TRANSMITTAL OF RESPONSES TO THE U.S. ENVIRONMENTAL
PROTECTION AGENCY AND THE OHIO ENVIRONMENTAL PROTECTION
AGENCY COMMENTS AND THE FINAL DESIGN OF THE WASTE HAUL ROAD
AND REROUTED NORTH ENTRANCE ROAD

**AUG 22 1996
DOE-1263-96**

**TECHNICAL REVIEW COMMENTS ON THE PREFINAL DESIGN
PACKAGE (90 PERCENT) AND DRAFT REMEDIAL ACTION WORK PLAN
FOR THE HAUL ROAD AND REROUTED NORTH ENTRANCE ROAD
FERNALD ENVIRONMENTAL MANAGEMENT PROJECT, FERNALD, OHIO**

FOR INFORMATION
FEMP ONLY
AREA 1 PHASE 1 (EAST)
REMEDIATION ACTION PROJECT
SITE PLAN 1 OF 3
SCALE: 1"=50'-0"

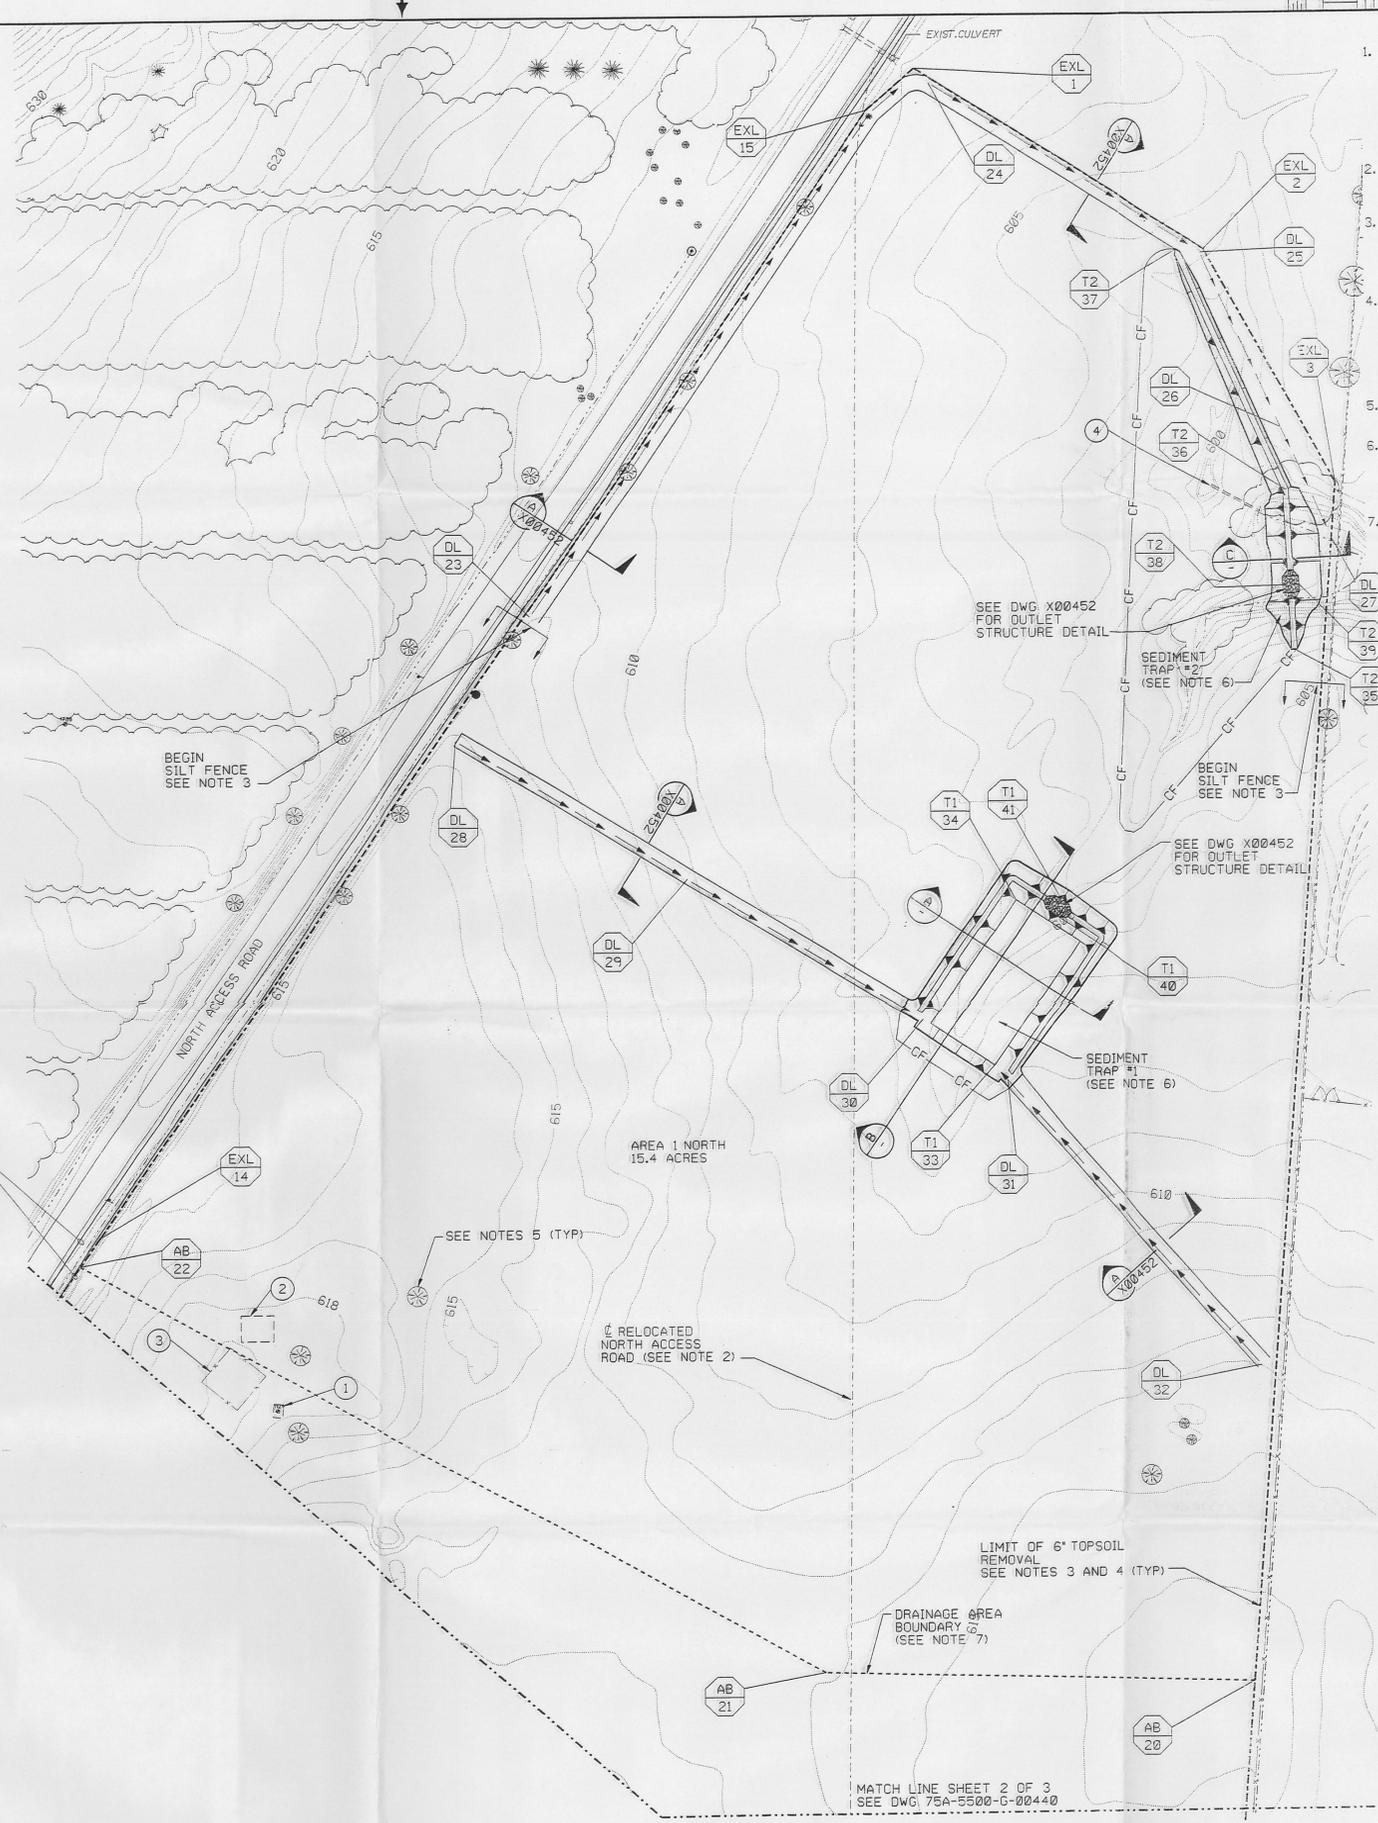
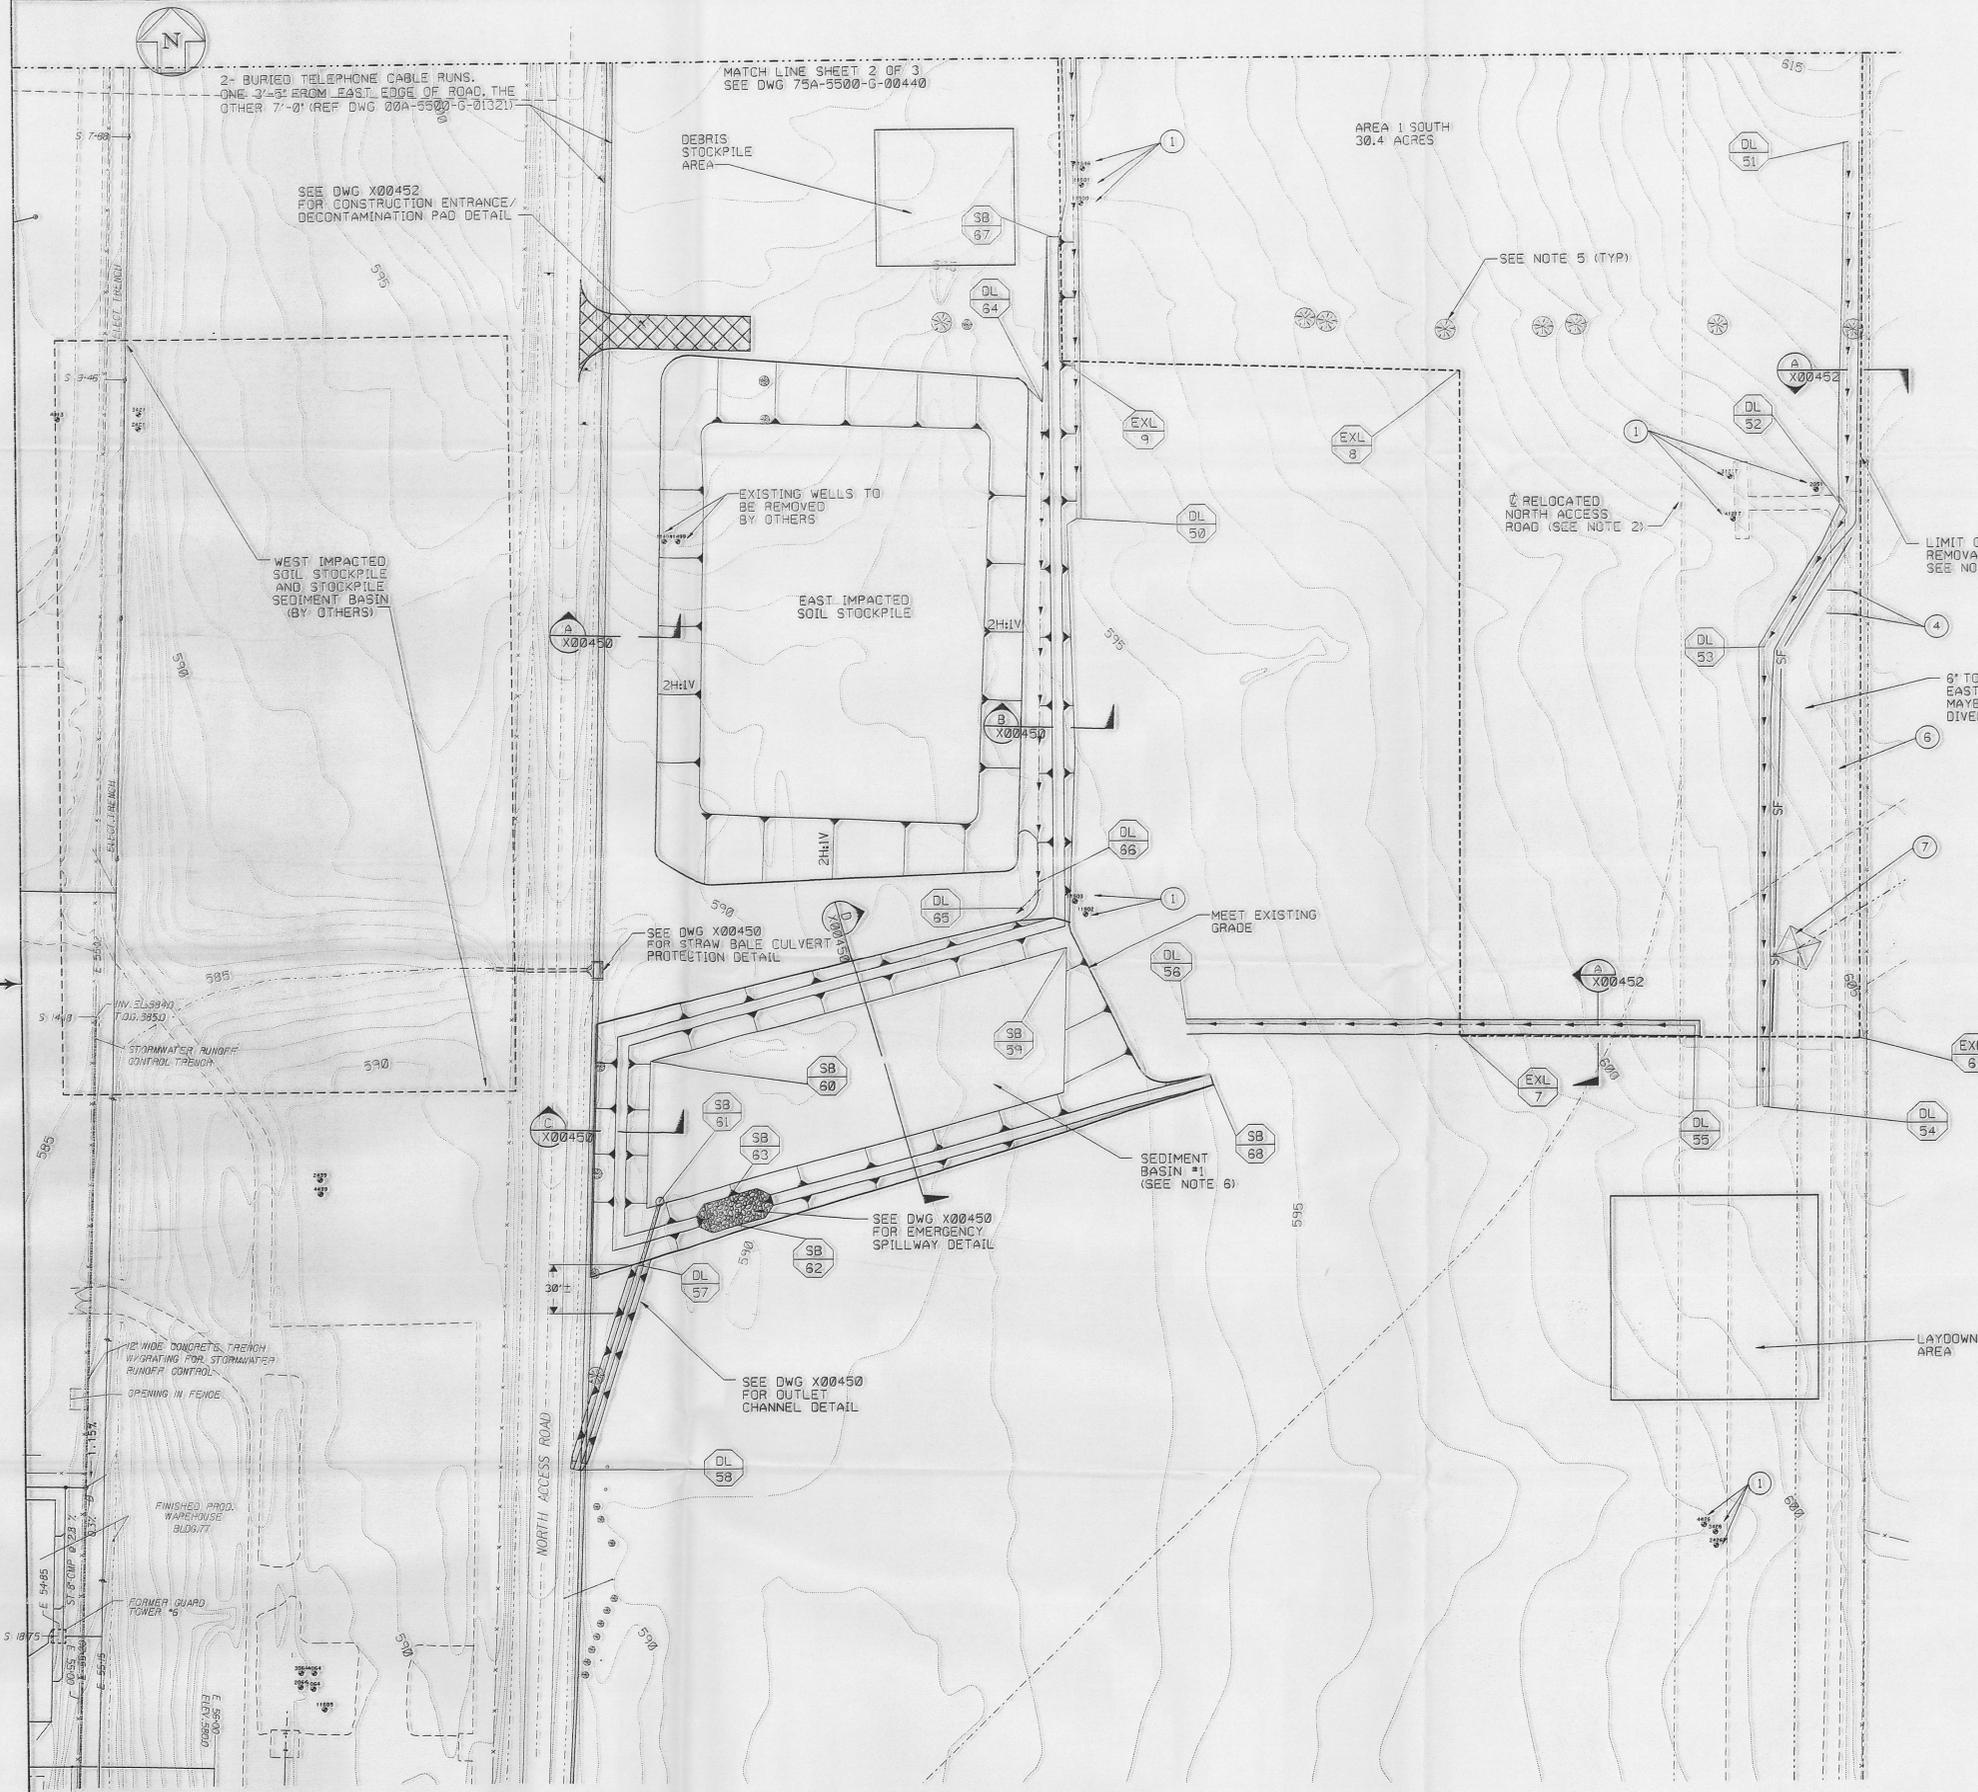
Comment: Section 2.3.1 states that temporary sedimentation basins will be used to prevent sedimentation from migrating off site. These sedimentation basins do not appear in any of the plans. The sedimentation basin locations should be shown in the final design package and in the temporary erosion control drawings for both the haul road and relocated north entrance road.

Response: Sediment basins and/or traps constructed for the Area 1 Phase I (East) Remedial Action Project will be used during construction of the Relocated North Entrance Road, Phase I. These will be in place when the road construction begins. The Haul Road has been designed to minimize the velocity in the ditches to less than two (2) feet per second, therefore ditch erosion should be minimal. The erosion and sediment control system shown on the 90 percent design drawings conservatively envelope ODOT standards, which allows much higher ditch velocities (i.e., 4 to 5 fps).

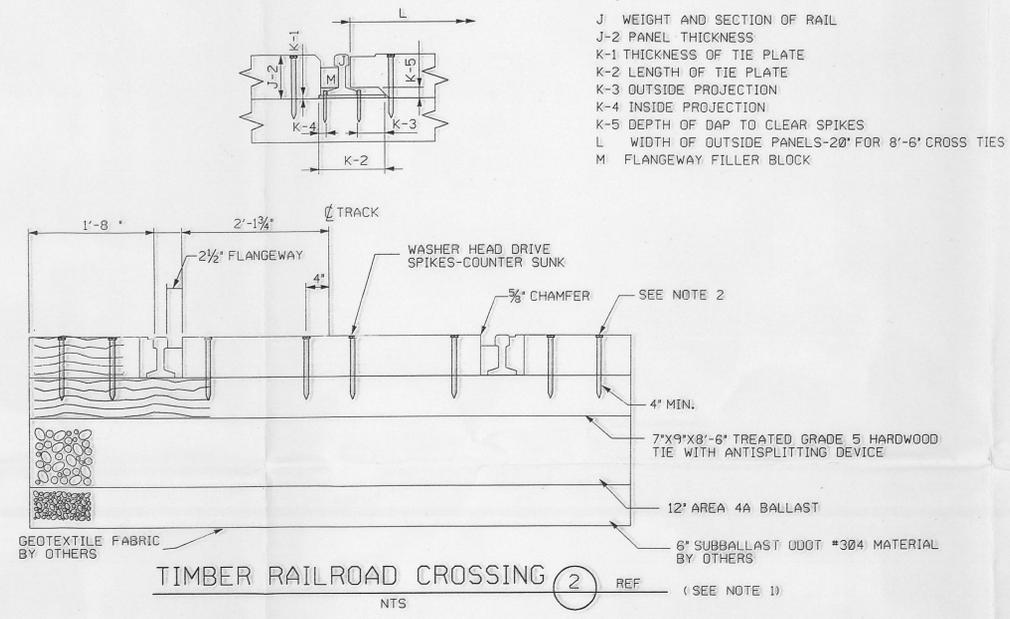
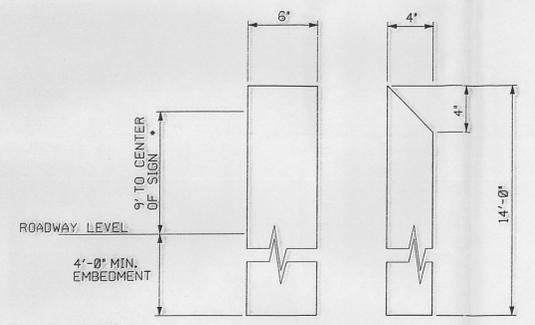
Comment: Drawing No. 92X-5900-00199 shows an intersection detail of the haul road and 2nd Street and a hatched section running approximately 100 feet diagonally across the haul road pavement at Station 129 +00. This hatched section represents a railroad crossing section with tracks running on top of the pavement. Drawing No. 92X-5900-00187 shows the plan and profile of the railroad crossing area. Note No. 6 of this drawing refers to Drawing No. 91X-5900-00230 for railroad crossing details, but Drawing No. 91X-5900-00230 is not included in the design drawing package. A detailed drawing should be included in the final submittal that incorporates details of Drawing No. 91X-5900-00230 and that shows how pavement grades from the existing concrete railroad crossing at 2nd Street and at the haul road crossing are matched.

Response: Note 6 states that drawing 91X-5900-G-00230 will be furnished to subcontractor upon request.

Action: A copy of drawing 91X-5900-G-00230 has been included in the CFC bid package and is attached for your information.

CHECK DAM DETAIL ① REF G00240 G00233 G00234

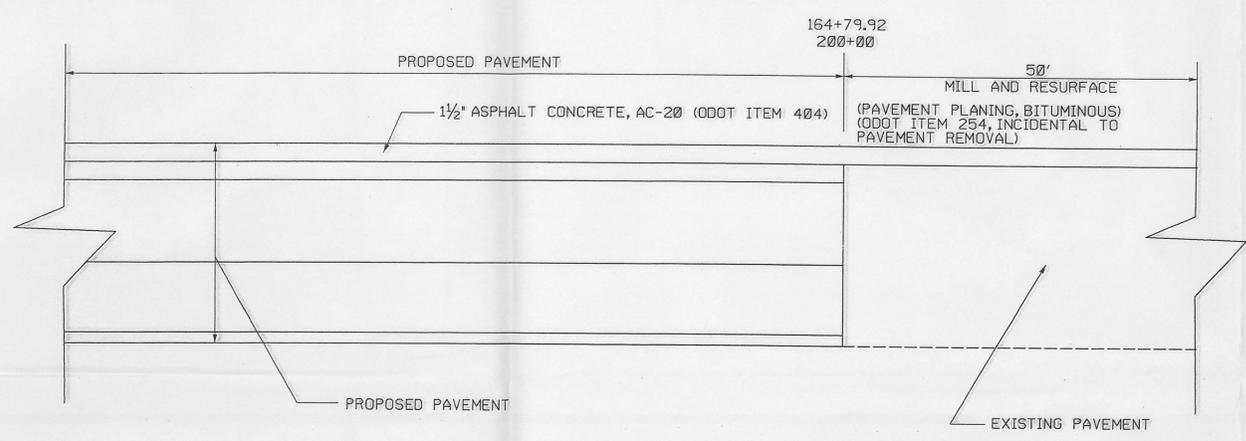
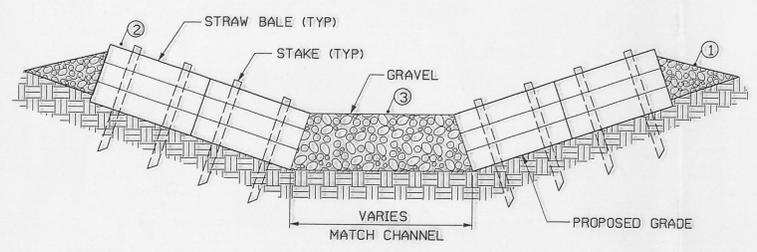
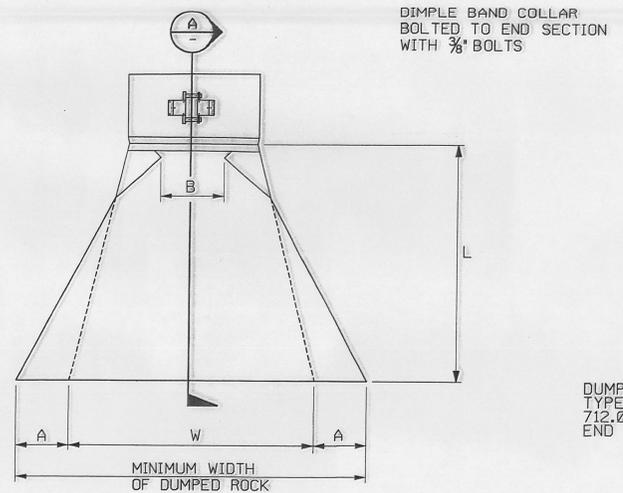
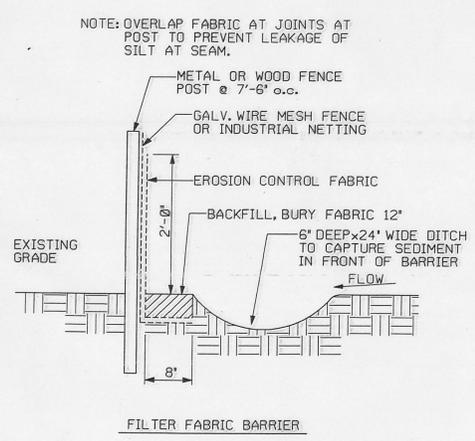
Commenting Organization: Ohio EPA Commentor: DSW
 Section#: Pg.#: Line#: Code:
 Original Comment# 6
 Comment: Check dams should conform to *Rainwater and Land Development*.
 Response: The composite rock/straw check dams shown on the drawings are consistent with the FEMP waste minimization program as the straw can be composted while the high porosity rock available in the Tri-State area will probably be cross-contaminated and require permanent storage in the OSDF. Therefore

the use of an all rock check dam as proposed in the Rainwater and Land Development document will generate significant additional waste. Material properties of rock in the Tri-State area (i.e., porosity, etc.) are documented in the report entitled *Off-Site Borrow Materials Geotechnical Evaluation Report*, forwarded to EPA/OEPA on July 19, 1996 (see DOE-1146-96). Also, because of the environmental compliance inspections mandated in the Stormwater Protection Plan at FEMP, straw bales will be expeditiously replaced in the event of observed degradation.

DRAWING TITLE
CIVIL GENERAL DETAILS SHEET 1 OF 2

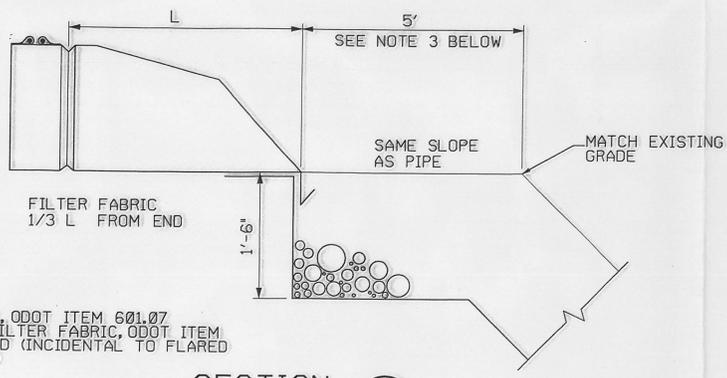
Comment: As discussed under Specific Comment No. 8 for the haul road, the rerouted north entrance road requires 12-, 21-, 24-, and 30-inch-diameter corrugated metal flared end sections in addition to the 15- and 18-inch-diameters indicated in accordance with Drawing No. 92X-5900-00217. The missing diameters should be added to this detail and diameters that are not applicable should be eliminated.

Response: DOE agrees.

Action: Detail 2 has been corrected on the CFC drawings to reflect the applicable flared end sections with the exception of 21" diameter. Since the flared end sections are standard for pipe diameters, the flared end section for a 21" will be shown as an as-built. Drawing 92X-5900-00240 is attached for review.
